September 26, 2025

**Re: Pre-Application Consultation Comments**  
Pre-Application No.: 25 221109 STE 04 PAC  
21 Windermere Avenue  
Ward 4 – Parkdale-High Park

Proposal: A mixed-use development by the Toronto Community Housing Corporation that includes a 35 storey tower and a U-shaped building comprised of 5- and 8- storey wings and a 20 storey component. The development includes small scale commercial and community uses at grade, as well as open space areas, a POPS, and above grade parking. A total of 763 affordable rental units are proposed, including 154 replacement rental units.

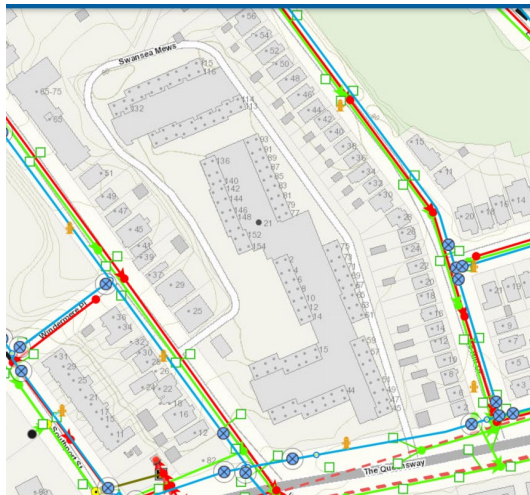
1. Based on unconfirmed City records, along Windermere Avenue there is the following City infrastructure:
  - a. 150 mm watermain
  - b. 300 mm sanitary sewer(s)
  - c. 525 mm storm sewer(s)

This map is for infrastructure visualization purposes only and must NOT be used as a replacement for utility locates, legal survey, as-built information, and suitable subsurface investigation. The Information is provided solely on an "as is" basis and the City makes no warranties or representations as to data quality.
